# Thoughts on Recent Groundwater- Model Applications in the Upper San Pedro Basin

**Upper San Pedro Partnership  
Technical Committee Meeting**

**December 4, 2012**

➤ Open-file Report 2012-1206—  
Evaluations of Simulations...

# Structure of model layers

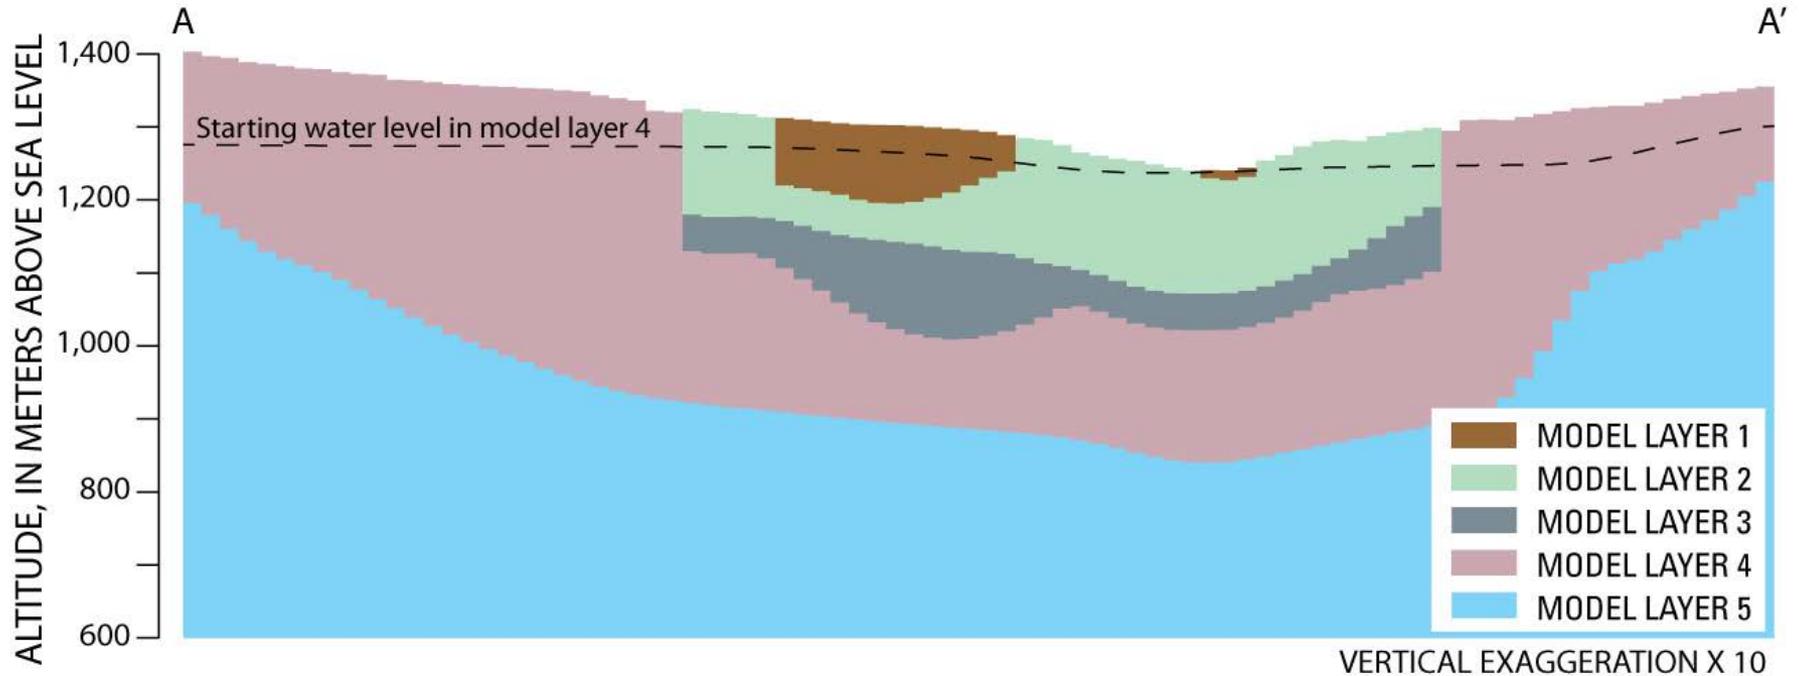
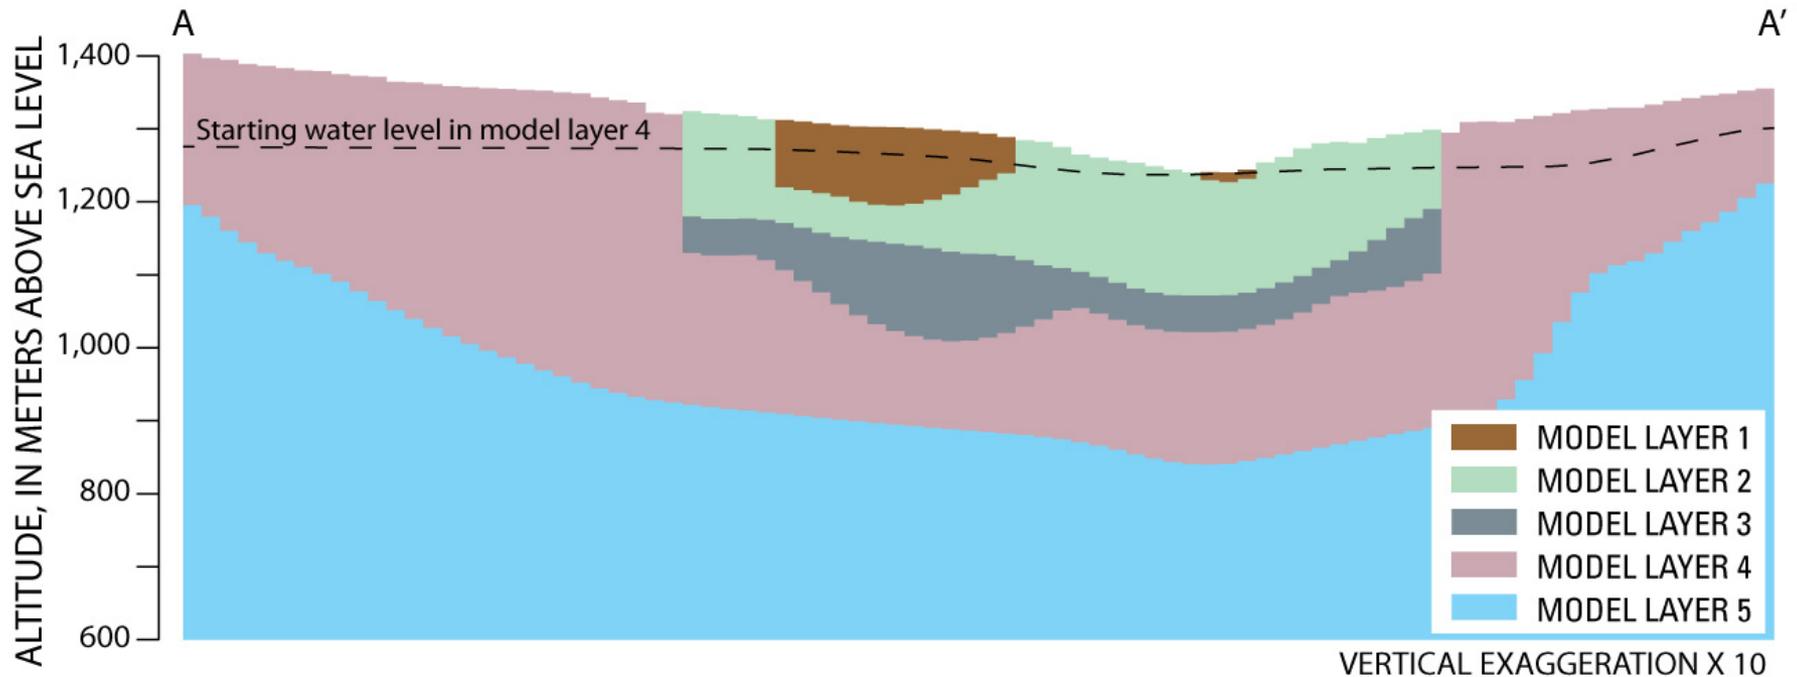
- Structure of model layers
- Effects of artificial model boundaries
- Effects of model detail on near-stream recharge simulations

# Effects of Artificial Boundaries

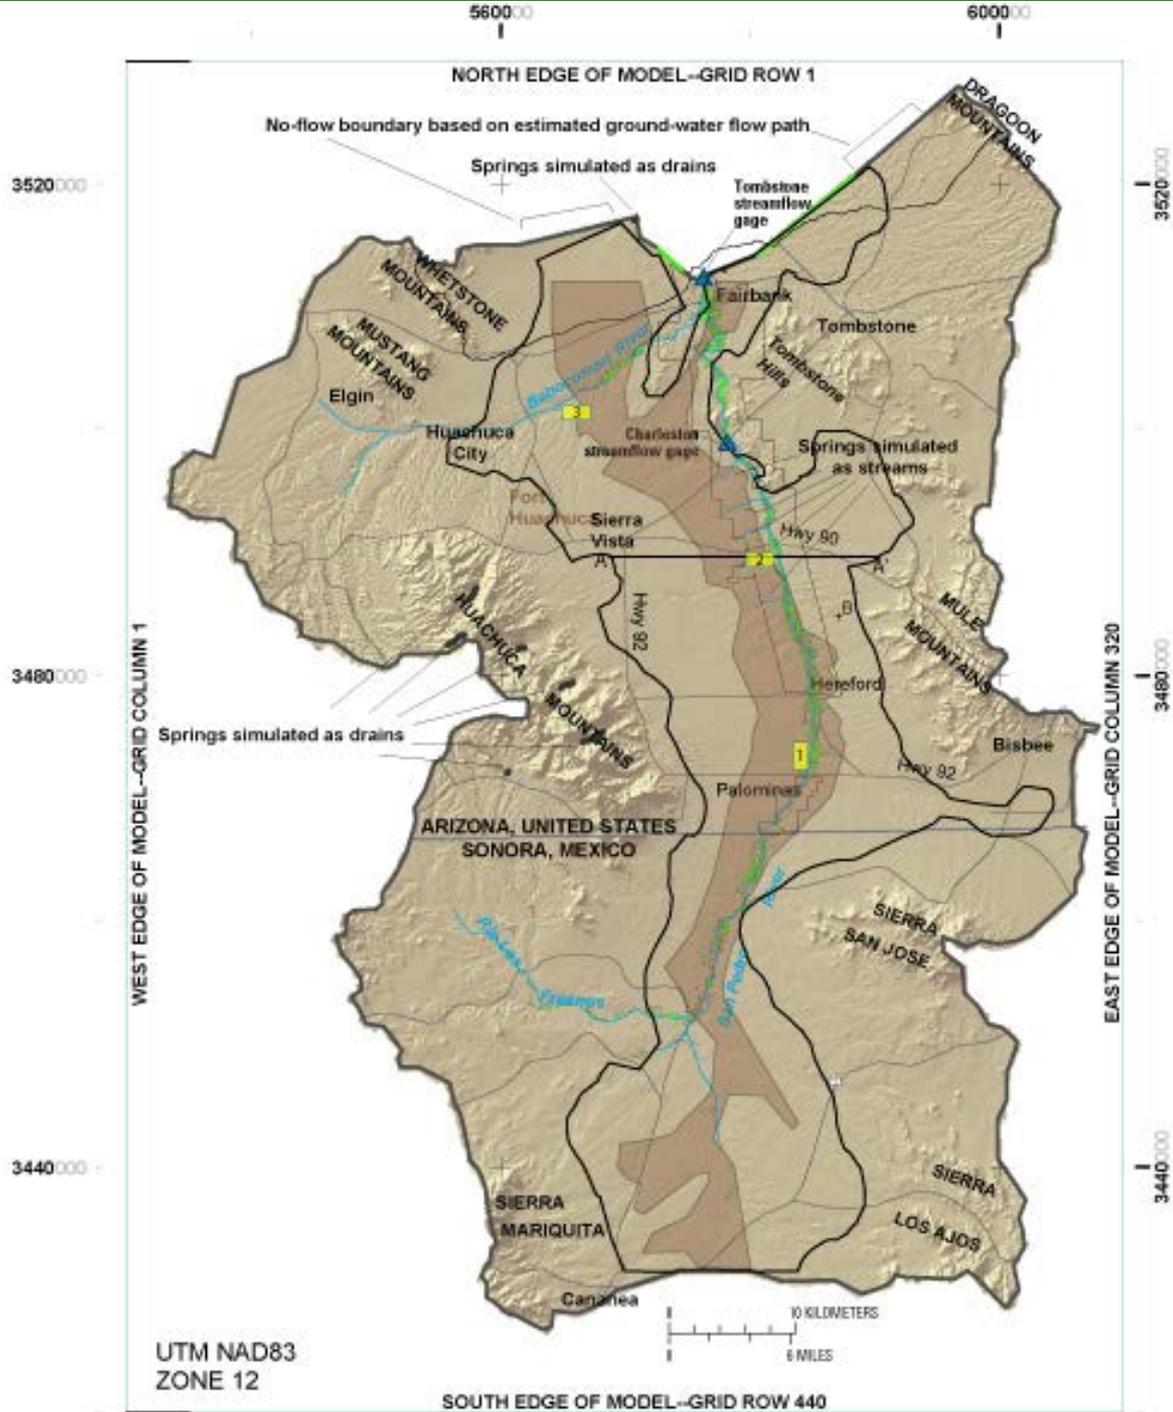
Possible areas of concern:

1. Artificial no-flow boundaries along the perimeter of the model
2. Artificial head-dependent boundaries along northern edge of model

# Effects of model detail on near-stream recharge simulations

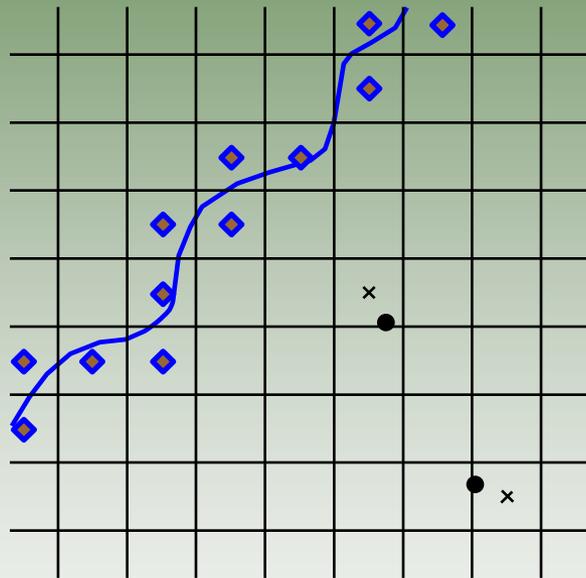
Possible errors in simulating timing of effects of artificial recharge could come from

1. Errors in distance between recharge and stream/ET areas caused by 250-meter grid spacing
2. Errors caused by finite-difference approximations of spatial distributions of recharge-induced water-level rises
3. Errors related to the crude approximation of the ET function in MODFLOW

# Effects of model detail on near-stream recharge simulations

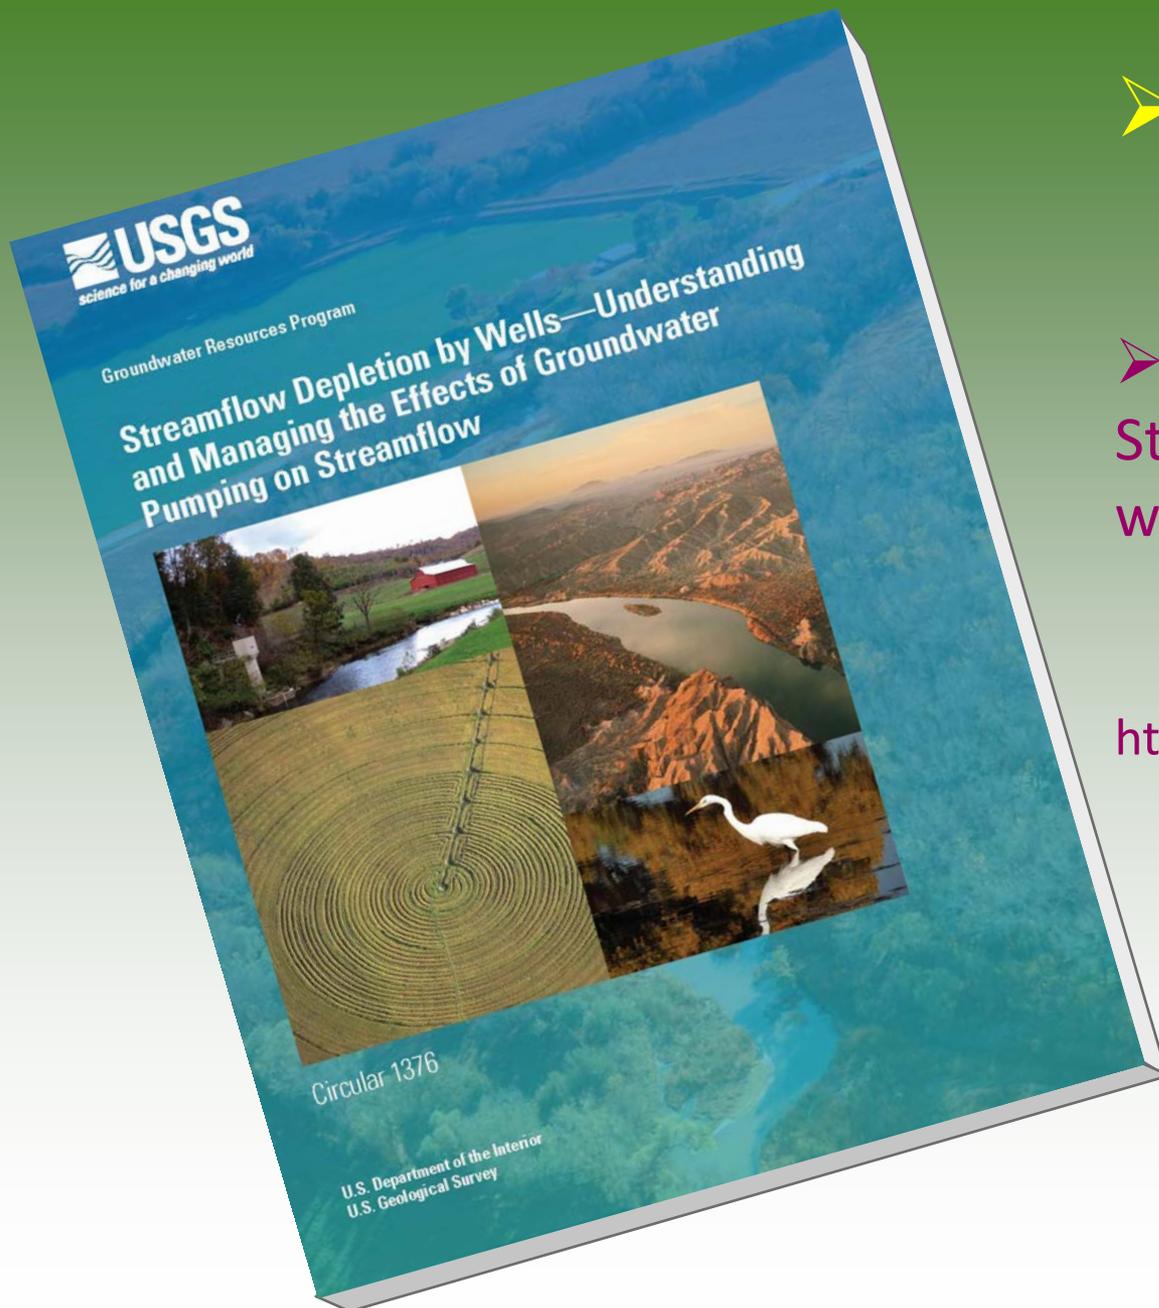
If the interest is in long-term effects, applications of the USGS model such as were carried out by Lacher are reasonable

1. Errors in distance between recharge and stream/ET areas caused by 250-meter grid spacing
2. Errors caused by finite-difference approximations of spatial distributions of recharge-induced water-level rises
3. Errors related to the crude approximation of the ET function in MODFLOW
